**National Committee on
Seismic Design Parameters (NCSDP)
for River Valley Projects**

**MINUTES
OF
28th MEETING
(9th January, 2015)**

**Foundation Engineering & Special Analysis (FE&SA) Directorate
Central Water Commission
New Delhi**

28.3.11 (New) Ganderbal HE Project, Jammu and Kashmir

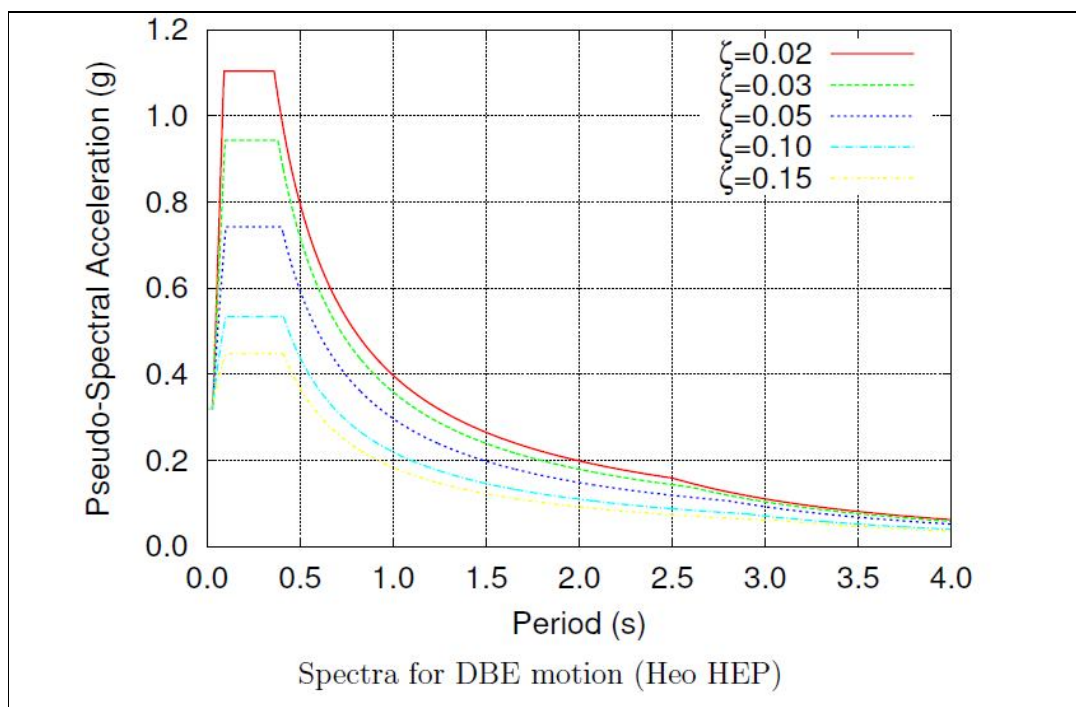
A presentation on the study report was made by the project authorities. Member Secretary mentioned that the title of the project name has been indicated as "Ganderbal" which needs to be corrected as "New Ganderbal". Sh. S.K. Sibal, Director, CWC pointed out that the recommendations on safety criterion such as permissible stresses are at variance with criteria given in guidelines. Accordingly, the Committee decided that recommendations on Safety criterion shall preferably be in accordance with the NCSDP guidelines, and any variation shall be recorded with justification. During discussion, it has also been pointed out that the values of horizontal peak ground acceleration (PGA) reported are on higher side. Further, Dr. L. R. Pattanur, CWPRS mentioned that the report should also incorporate the response spectra for 15% damping ratio along with time histories and response spectra both at river bed level (considering overburden) as well as at the rock outcrop/bed rock level.

After brief deliberation, the Committee decided that the study needs to be revised in view of above observations made by the Committee and resubmitted for consideration of the Committee.

Spectra for DBE motion (Heo HEP)

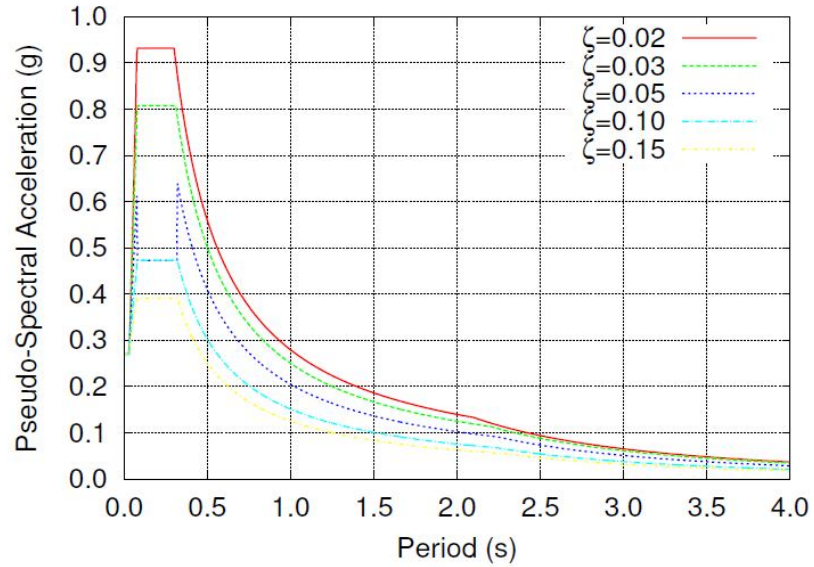
A presentation on the study report was made by the project authorities. Sh. S.K. Sibal, Director, CWC pointed out that the recommendations on safety criterion such as permissible stresses are at variance with criteria given in guidelines. Accordingly, the Committee decided that recommendations on Safety criterion shall preferably be in accordance with the NCSDP guidelines, and any variation shall be recorded with justification. Further, Dr. L. R. Pattanur, CWPRS pointed out that the report should also incorporate the response spectra for 15% damping ratio along with time histories and response spectra both at foundation (river bed) level as well as at the rock outcrop/bed rock level. In response, the representative from IIT Roorkee has mentioned that there will be no change in the recommended seismic design parameters on account of these observations. However, they agreed to incorporate the requisite information in the study report. Accordingly, IITR has provided the response spectra for 15% damping ratio along with safety criteria vide their letter dated 27.04.2015 and e-mail dated 29.04.2015. It has also been mentioned that the spectra and time histories for motion at bedrock level have been included in the report and will be submitted for records; the

design parameters are based on the motion at the river bed level which is already included in the report and hence there is no change in the estimation of seismic design parameters.

Please see the attached document for DBE response spectra in color. The spectra and time histories for motion at bedrock level for Heo HEP are included in the revised report which is being sent for your records. However, the design parameters are based on the motion at the riverbed level which is already included in the report and hence there is no change in the estimation of seismic design parameters.
